Appln. No. 10/657,403

Amendment dated April 17, 2006

Reply to Office Action of January 24, 2006

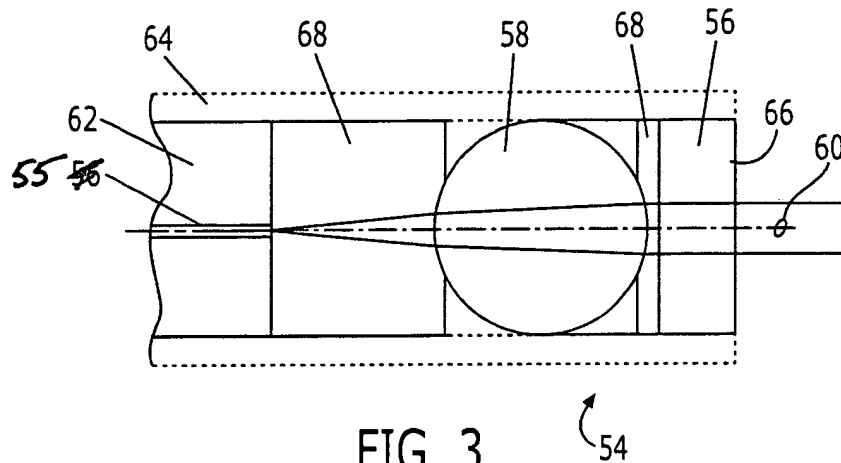
With the consent and approval of the Examiner, Applicants propose to amend Fig. 3 as shown in red in the following sketch:

Applicants propose to amend Fig. 3 of the drawings as indicated in red on the indicated sketch. The change here is to have reference numeral 56 refer to the interface optical element, and to use reference numeral 55 to refer to the optical fiber, as discussed *supra* with respect to the changes to the specification. Clearly, these proposed changes to the drawing do not seek to add "new

matter". A new drawing figure to replace Fig. 3 is submitted herewith in the appendix.
